**Subject: MHI's Response to US-APWR DCD RAI No. 492-3898 Rev. 1**

**RAI NO.:** NO. 492-3898 REVISION 1  
**SRP SECTION:** 15.00.03 – Design Basis Accidents Radiological  
Consequence Analyses for Advanced Light Water  
Reactors  
**APPLICATION SECTION:** 15.0.3  
**DATE OF RAI ISSUE:** 11/23/2009

**QUESTION NO. : 15.00.03-32**

Figure 1 Areas for calculating water volume in RWSP

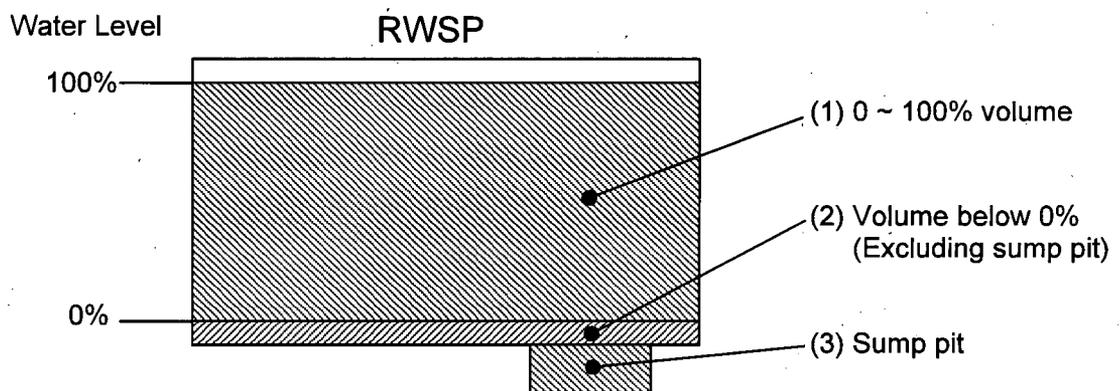
In the response to Question 15.00.03-29 (Ref. 1), the applicant stated that the volume of water assumed in calculating the post-accident pH to determine the minimum required amount of NaTB buffer is 879,690 gallons (3,330 m<sup>3</sup>). However, in DCD Table 6.2.5-1, the maximum RWSP volume is given as 651,000 gallons. Further, the response to RAI 15.00.03-27 indicated that 134,730 gallons of RCS water was assumed to be discharged to the sump. The sum of 651,000 gallons plus 134,730 gallons equals 785,730 gallons, which is considerably less than the figure of 879,690 gallons.

Please explain the basis for the use of 879,690 gallons for calculating the minimum amount of buffer. The basis should detail the contributions from the various volumes such as the RWSP, RCS, accumulators, any other significant contributions, and any margin added for conservatism.

The basis for 3,330 m<sup>3</sup>(879,690 gallons), which is used to calculate the minimum buffering agent volume, is shown in Table 1. Margin is not considered except the round-up.

Water source	Volume (m <sup>3</sup> )	Basis
RWSP	2,520	Maximum RWSP inventory at normal operation (See Figure 1).  (1) 0 ~ 100% volume: 81,307.6 ft <sup>3</sup> (2) Volume below 0% (excluding sump pit): 5,678.3 ft <sup>3</sup> (3) Sum of four sump pits volume: 1,045.7 ft <sup>3</sup>  (1)+(2)+(3) = 88,031.6 ft <sup>3</sup> ≈ 89,000 ft <sup>3</sup> (2,520 m <sup>3</sup> )
Accumulators	300	Total accumulator water volume = [tank total volume - tank minimum gas space volume] x [Number of Accumulator] = (90m <sup>3</sup> - 15.3m <sup>3</sup> ) x 4 = 298.8 m <sup>3</sup> ≈ 300 m <sup>3</sup>
RCS	510	RCS volume including pressurizer full volume : 502.6 m <sup>3</sup> ≈ 510 m <sup>3</sup>
Total	3,330	2,520 + 300 + 510 = 3,330
